1、 Part name :180809 Spule V2 #2

13、 Type of Mold : **Production Mould**

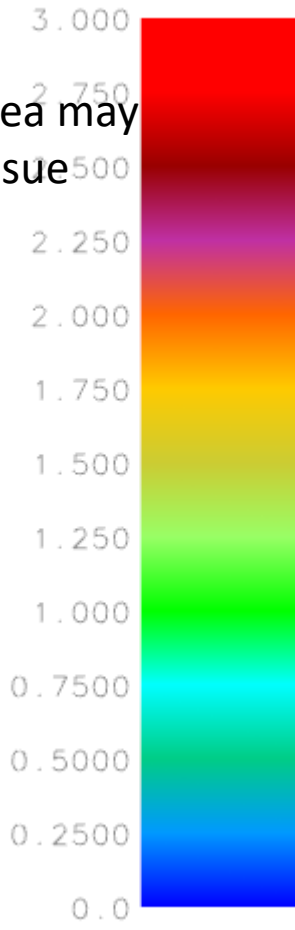
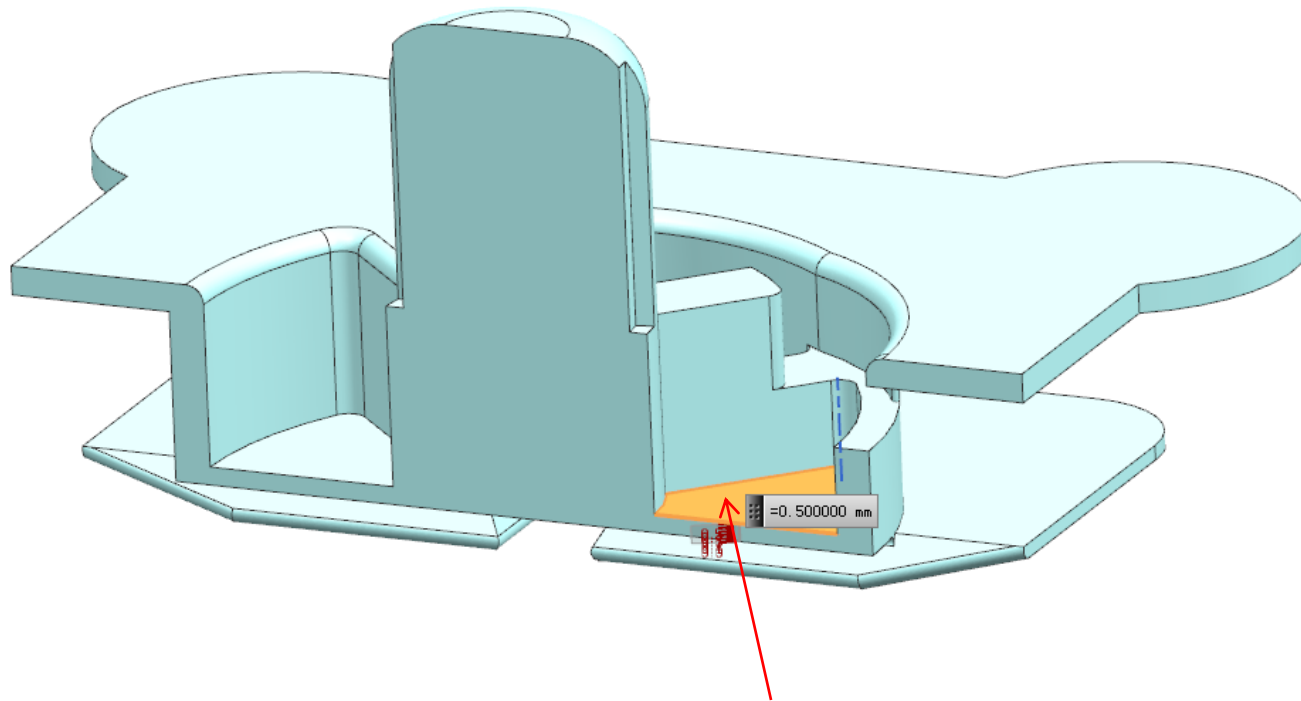
All of those red area may have sink marks issue

Wall thickest area is 7.4, average wall thickness is 1mm

Thickness analyze

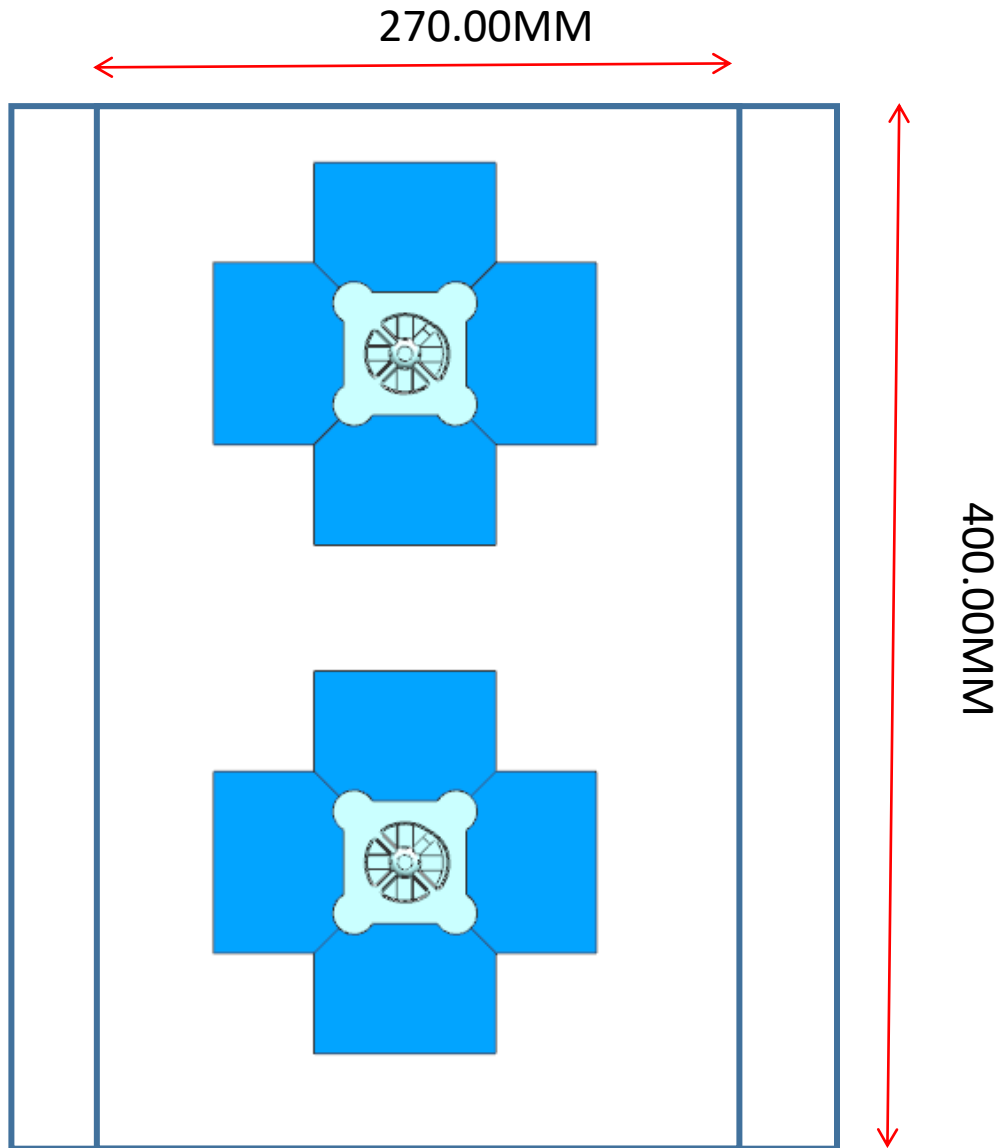
This area today is 0.5mm only, we suggest to add to 1mm, please check and confirm?
